Synthetic Review Drawing Stub

Part	Hot-melt nozzle mounting bracket with heat shield
Revision	B
Pilot	WEBASTO
Material	Stainless steel

Views

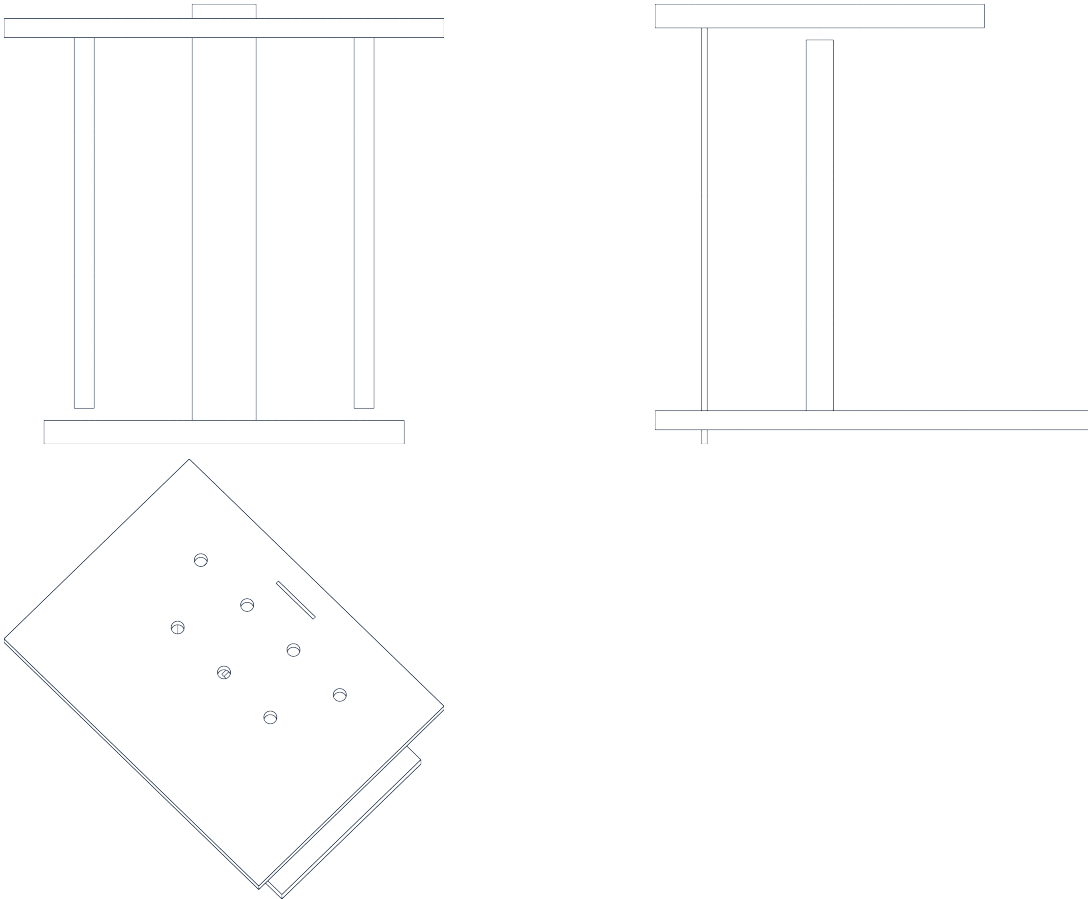
- Shift the nozzle centerline by 3 mm.
- Expand the adjustment-slot range and add locating holes.
- Add extra shield ventilation holes for the revised heat profile.
